63 Hillfield Road, London,
NW6 1QB

Basement Impact Assessment
Audit

For
London Borough of Camden

Project Number: 12466-96

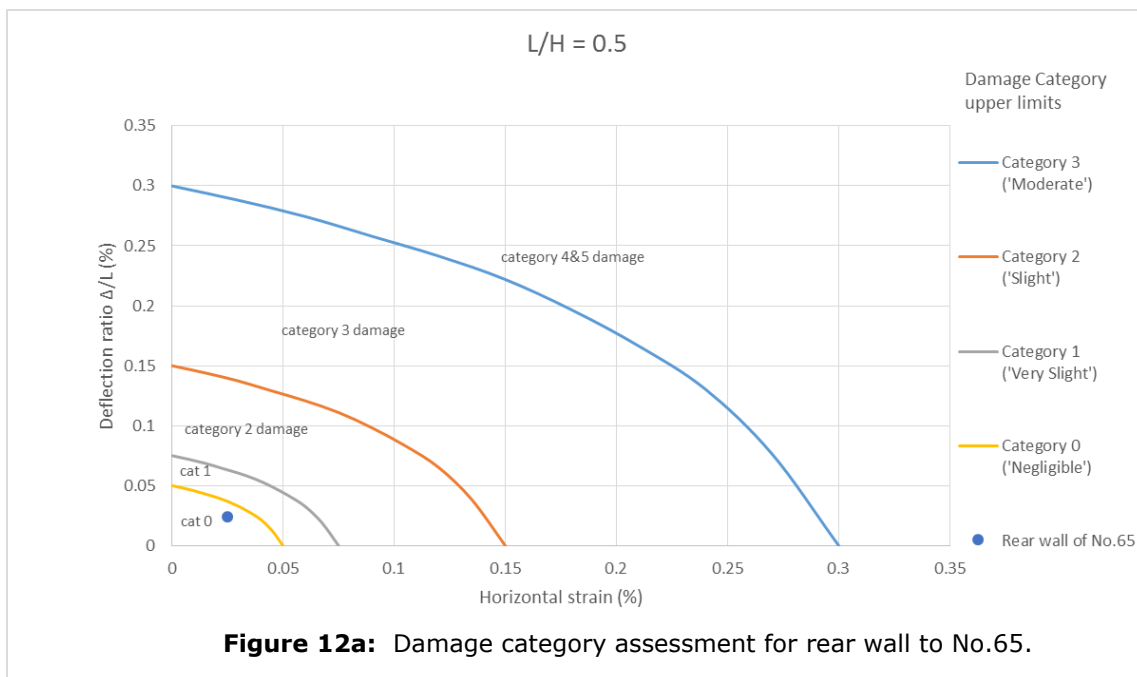
The damage category assessment for the rear wall of No.65 has been reviewed in light of these revised PDISP analyses (previously presented in paragraphs 10.7.3 to 10.7.9 of the BIA report 18630/R3). The horizontal strain would remain unchanged at $\epsilon_h = 2.5 \times 10^{-4}$ (0.025%).

The maximum settlement predicted by the PDISP analysis alongside the basement, beneath No.65’s rear wall, has remained at 2-2.5mm in Stage 3 and increased to 3.5-4.5mm in Stage 4 (with maximum settlement at the centre of the PDISP zone also increasing by 0.5mm to 7.5mm). The differential between these values (1.5-2mm, also increased by 0.5mm) gives the long-term plastic deformation, which must be combined with the settlement caused by relaxation of the ground alongside the basement in response to excavation of the underpins, which can be estimated using the settlement profile for the worst case (low stiffness) scenario presented in Figure 2.11(b) of CIRIA Report C580. The latter is 0.35% of the excavation depth, which for a 1.0m excavation depth gives a predicted settlement of 3.5mm; that increases to 5.0-5.5mm when combined with the PDISP-predicted 1.5-2mm long-term displacement differential. The maximum predicted deflection, Δ can then be obtained from CIRIA’s settlement profiles chart (op cit). For the worst case scenario $\Delta = 17\%$ of the maximum settlement, hence the maximum $\Delta = 5.5 \times 0.17 = 0.94\text{mm}$, which represents a deflection ratio, $\Delta/L = 2.35 \times 10^{-4}$ (0.024%).

Using the graphs for $L/H = 0.5$ as before, these deformations represent a damage category which remains well within the ‘negligible’ Burland Category 0 ($\epsilon_{lim} = <0.05\%$) as given in CIRIA SP200, Table 3.1, and illustrated in Figure 12a below.

Figure: G1a

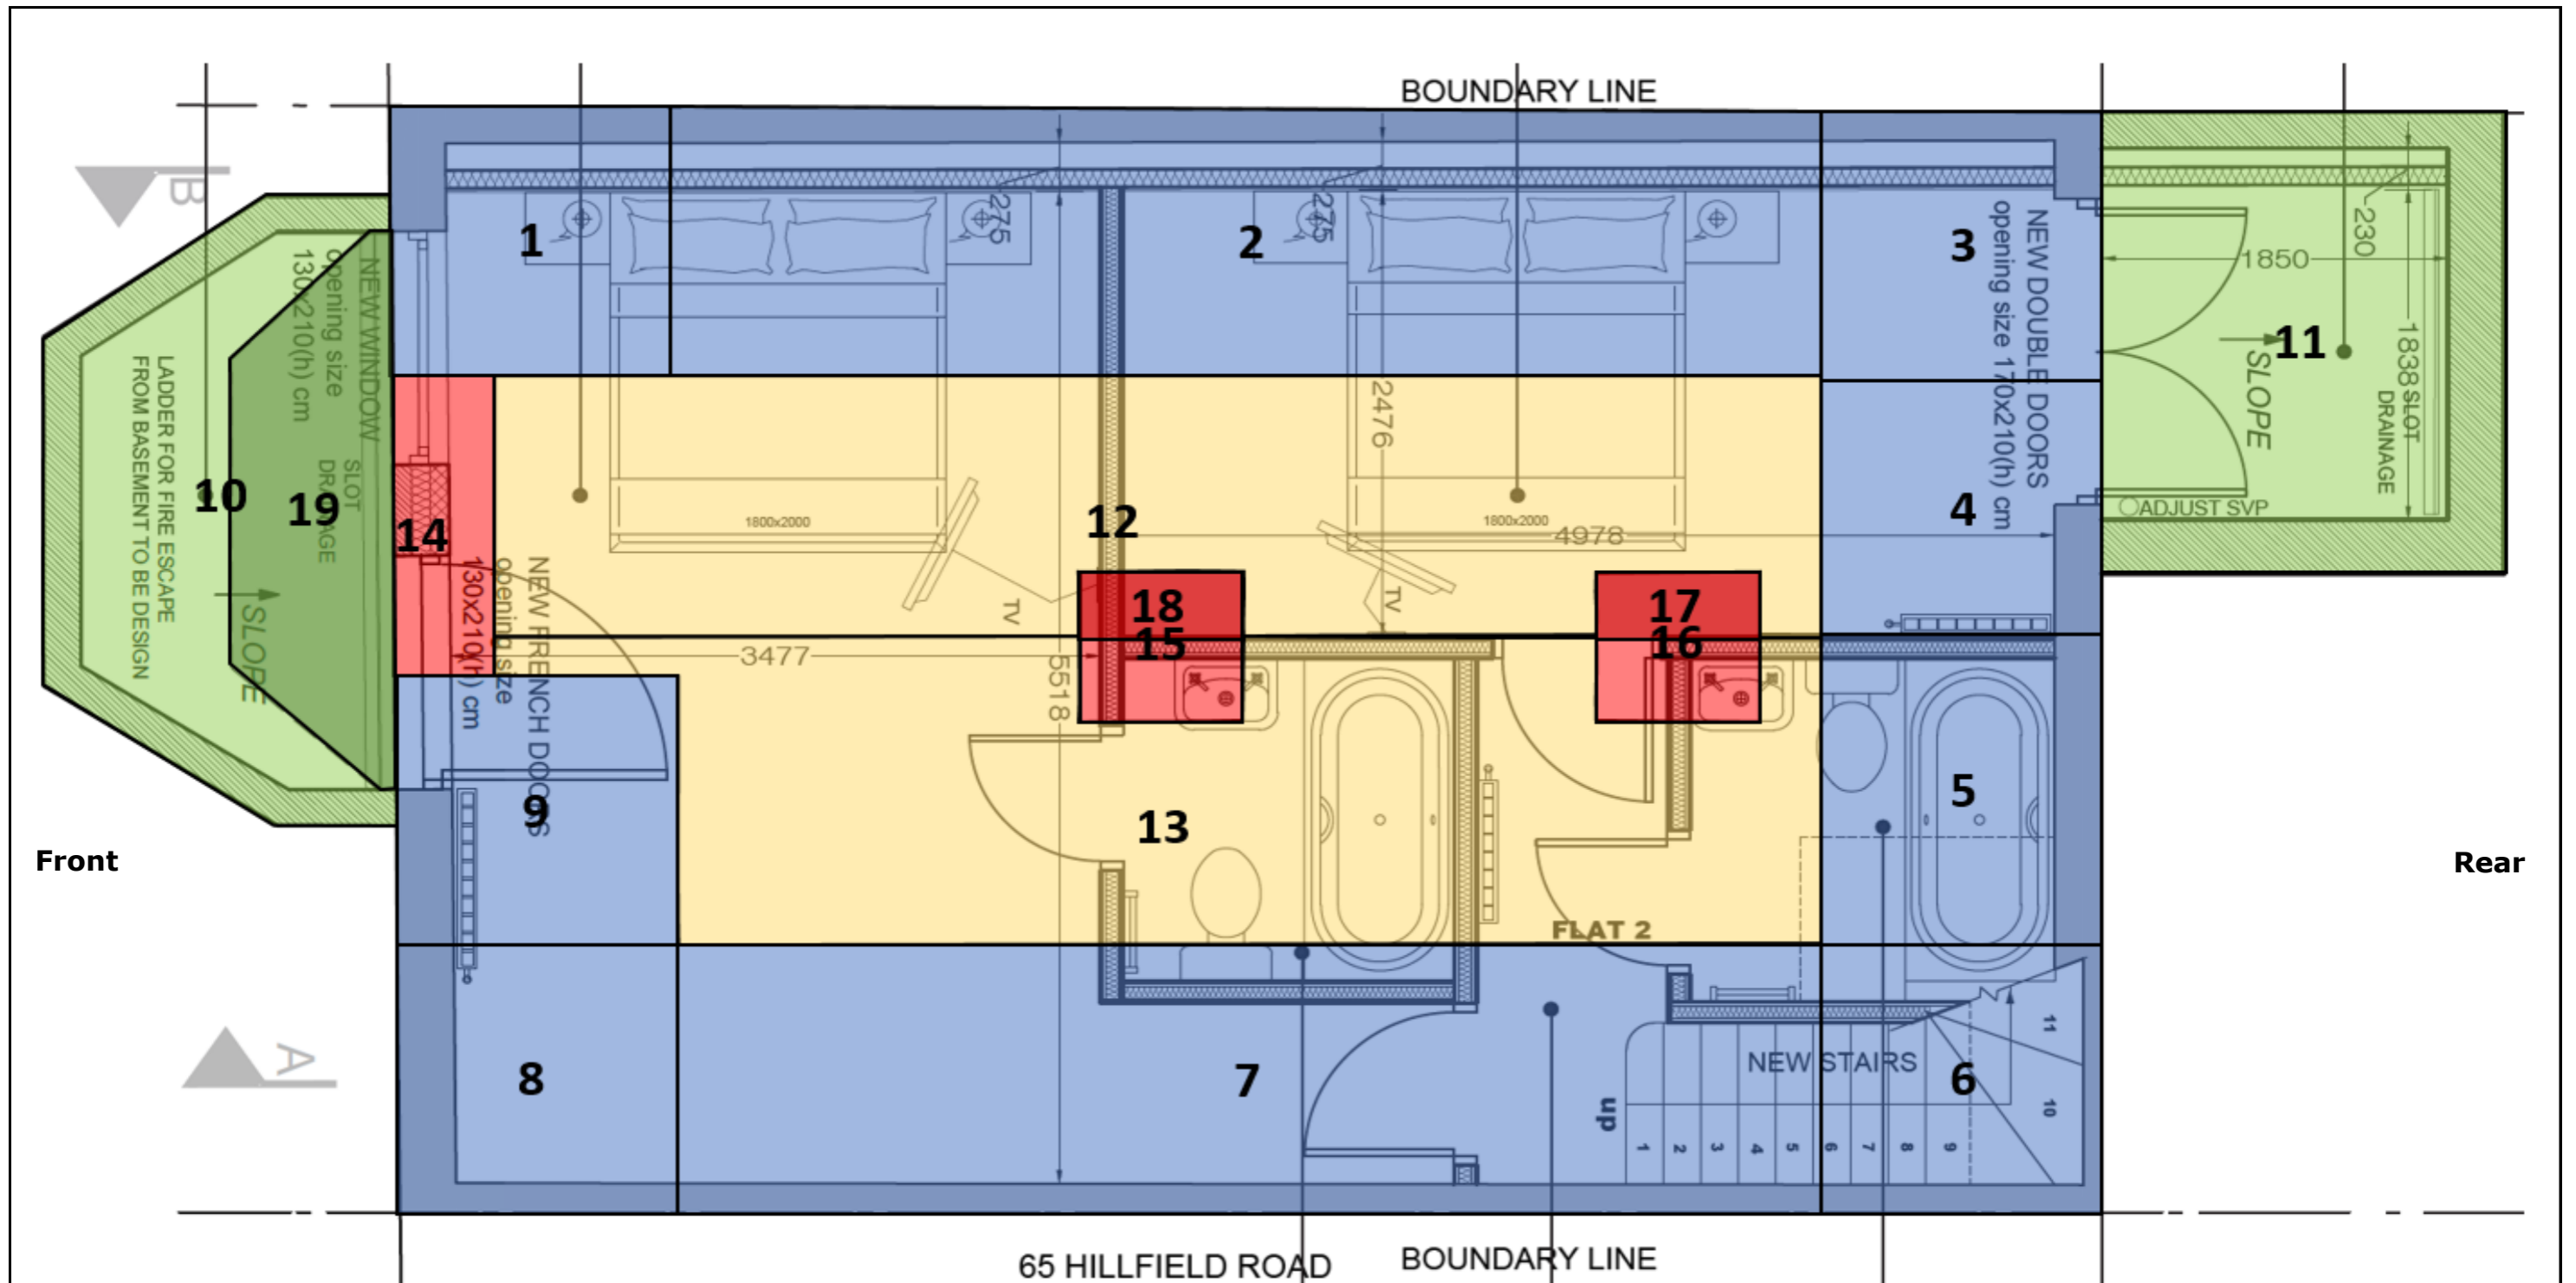
- Your bearing capacity assessments seem reasonable, however as you note 25mm settlement along party walls will be a problem. The SE's loads are significantly higher than your capacities (depending on your foundation dimension), which would suggest settlement will only become higher. - **Keith to respond. All net bearing pressures calculated for the PDISP analyses using GSE's load takedown for the retrofit basement are now below the 100kPa recommended maximum.**

As requested by Campbell Reith we have revised the PDISP analyses for the retrofit basement beneath No.63 as follows:

- Reduced the undrained shear strength (cohesion) C_u of the clays at basement formation level from 50kPa to 45kPa;
- Reduced the bearing pressure on Zone 14 (which supports the pier between the windows in the front lightwell) to less than the maximum allowable bearing pressure of 100kPa which was proposed in paragraph 10.4.11 of our BIA (ref: 18630/R3); this was achieved by increasing the width of the Zone 14 from 0.35m to 0.55m, with associated slight reduction to the area of the central basement slab (Zones 12 & 13).

Revision 1: Width of Zone 14 increased from 0.35m to 0.55m.

Figure: G4a

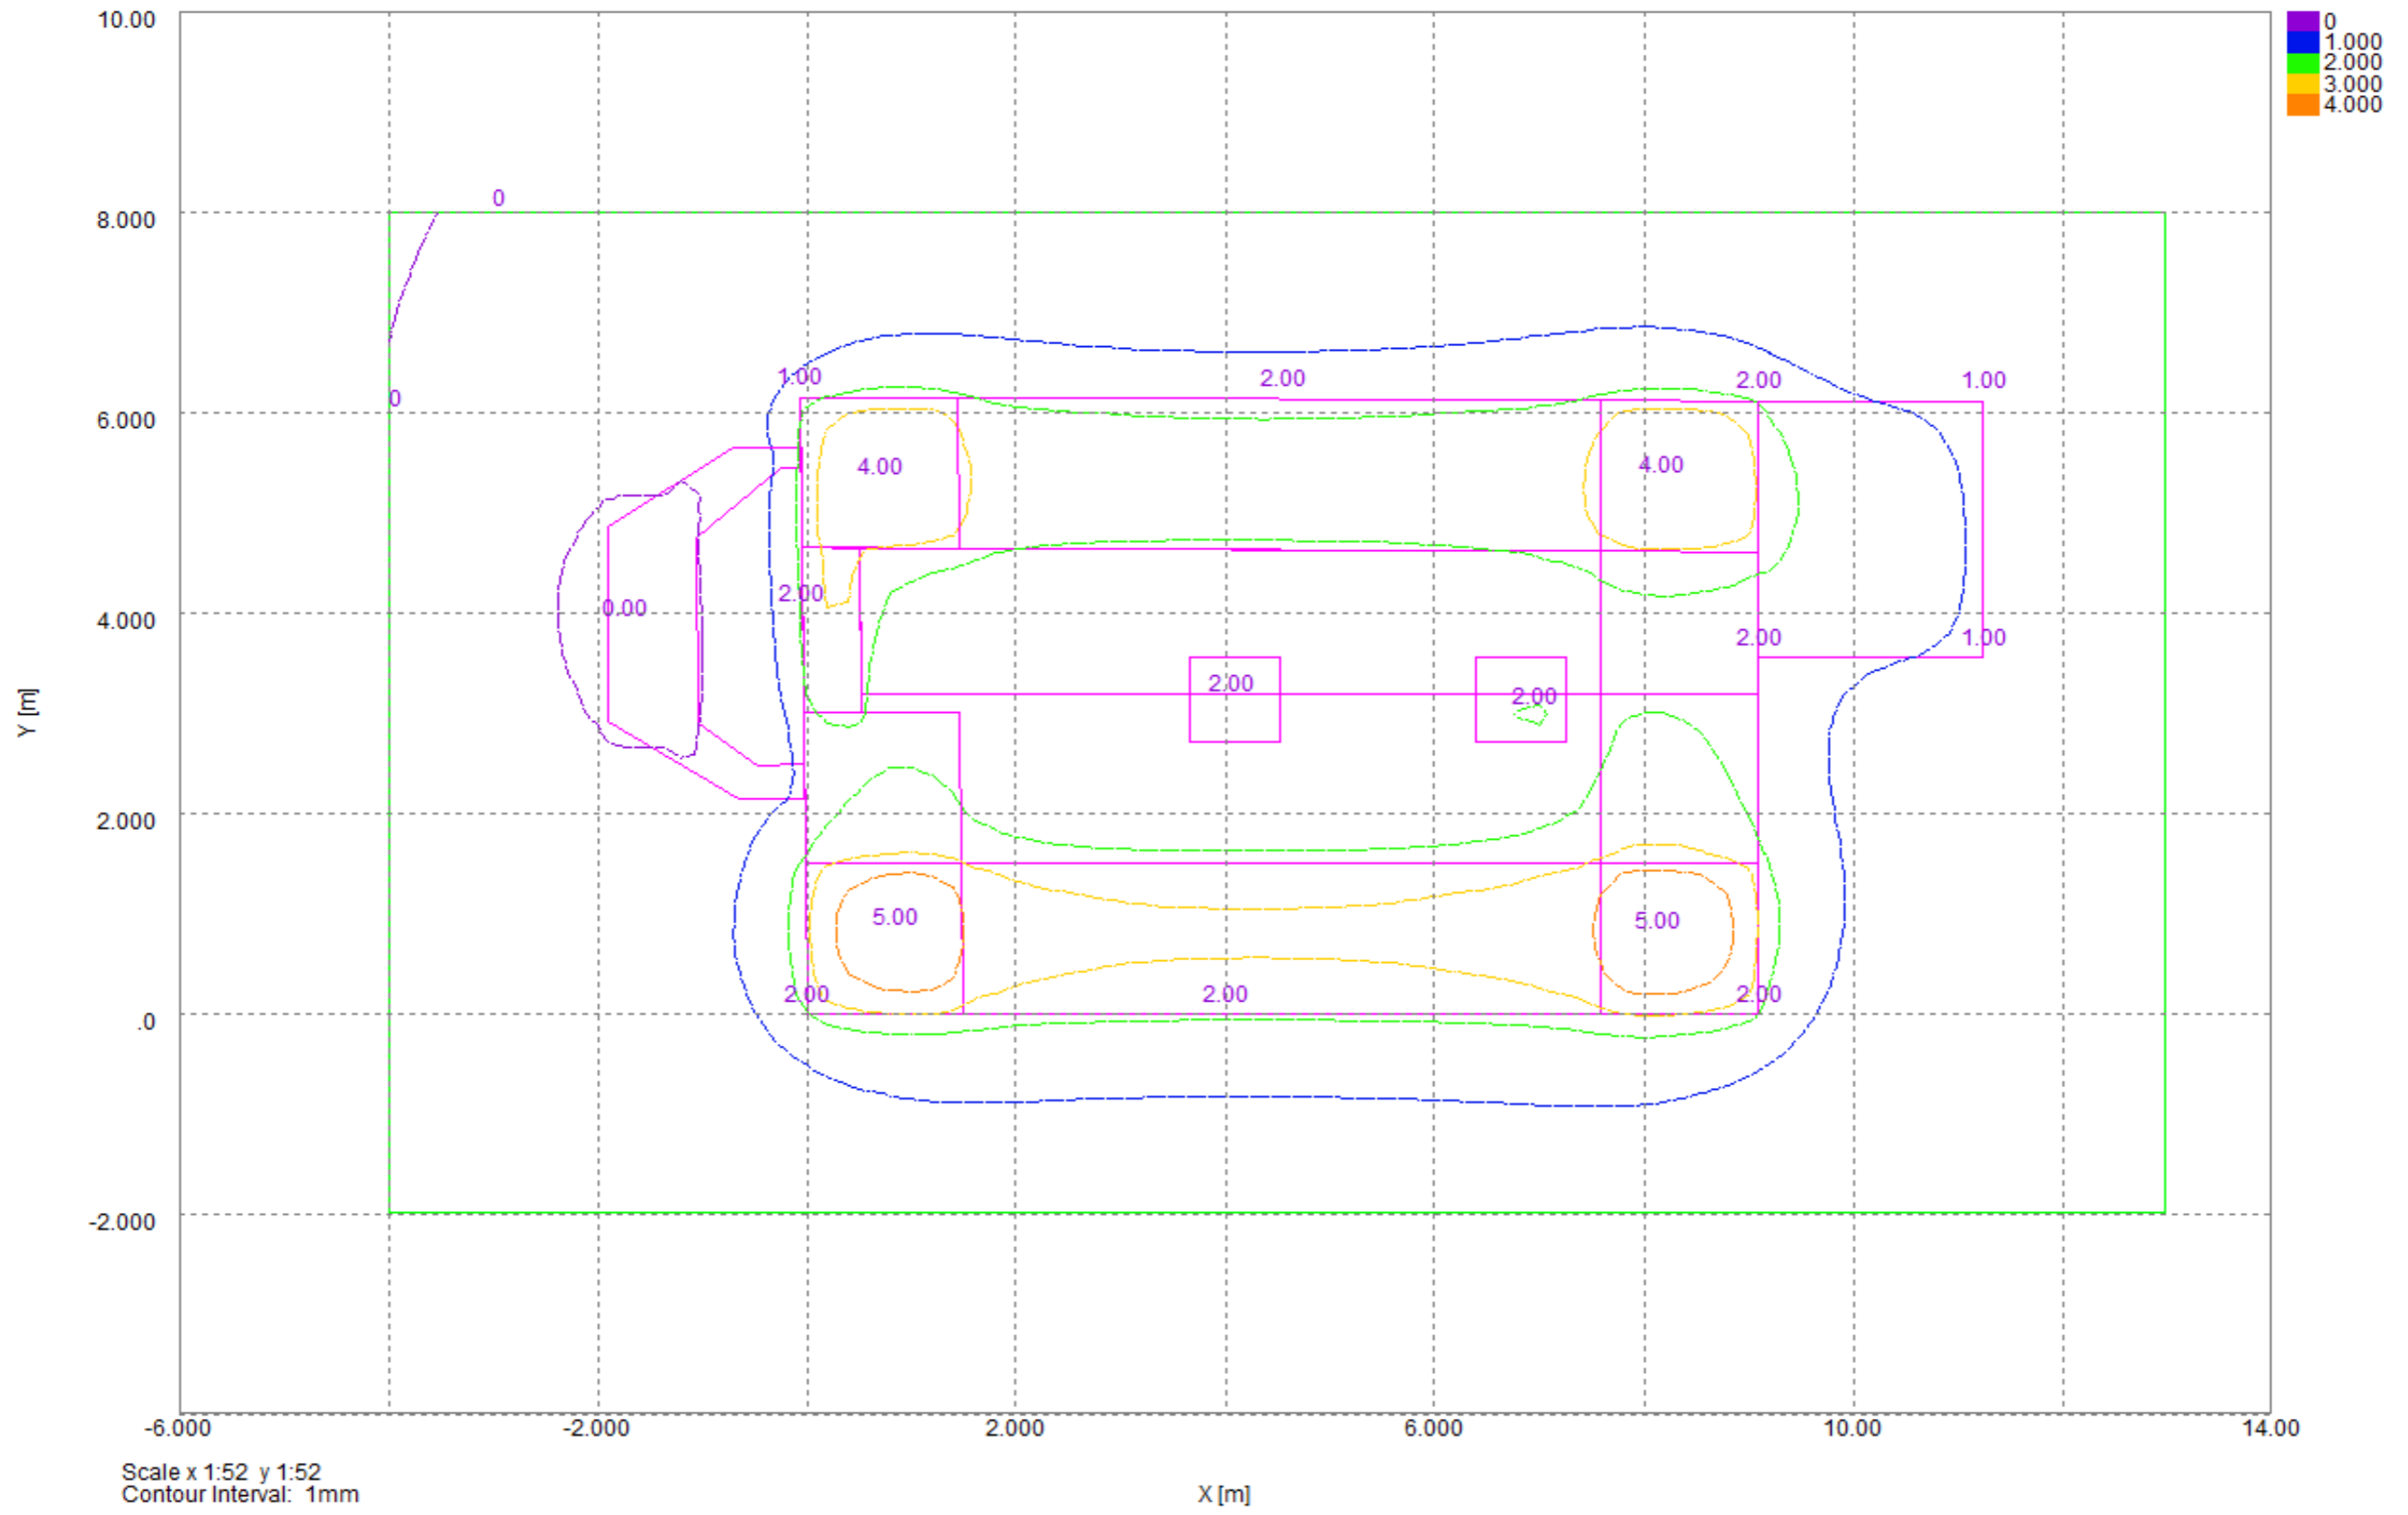
The revised soil parameters are given in Table 4a below, and the revised PDISP figures are presented on the attached Figures G1a and G4a to G7a (Figures G2 and G3 have not changed, but are included here for convenience). The revised summary of predicted displacements is in presented in Table 5a below.

Table 5a: Summary of predicted displacements				
Location	Stage 1 (Figure D4)	Stage 2 (Figure D5)	Stage 3 (Figure D6)	Stage 4 (Figure D7)
Front lightwell	0 - 2 mm Settlement	2mm Settlement to 0.5mm Heave	2mm Settlement to 0.5mm Heave	3.5mm Settlement to 1.5mm Heave
Front wall of basement (incl. column)	1 - 5mm Settlement	1 - 4mm Settlement	0.5 - 4mm Settlement	1.5 - 7.5mm Settlement
61/63 party wall	1.5 - 4mm Settlement	0 - 4mm Settlement	1 - 4mm Settlement	1 - 6mm Settlement
Rear lightwell	0.5 - 3mm Settlement	0.5 - 2.5mm Settlement	0.5 - 2.5mm Settlement	1 - 4.5mm Settlement
Rear wall of basement	1 - 5mm Settlement	1 - 4mm Settlement	1 - 5mm Settlement	1 - 7.5mm Settlement
63/65 party wall	2 - 5mm Settlement	1 - 4mm Settlement	1 - 5mm Settlement	2.5 - 7.5mm Settlement
Internal columns	2mm Settlement	1mm Settlement to 1.0mm Heave	0 - 1mm Settlement	2mm Settlement to 0.5mm Heave
Central basement slab	1.5 - 3mm Settlement (No slab present)	2mm Settlement to 1mm Heave (No slab present)	3mm Settlement to 1mm Heave	4mm Settlement to 1mm Heave
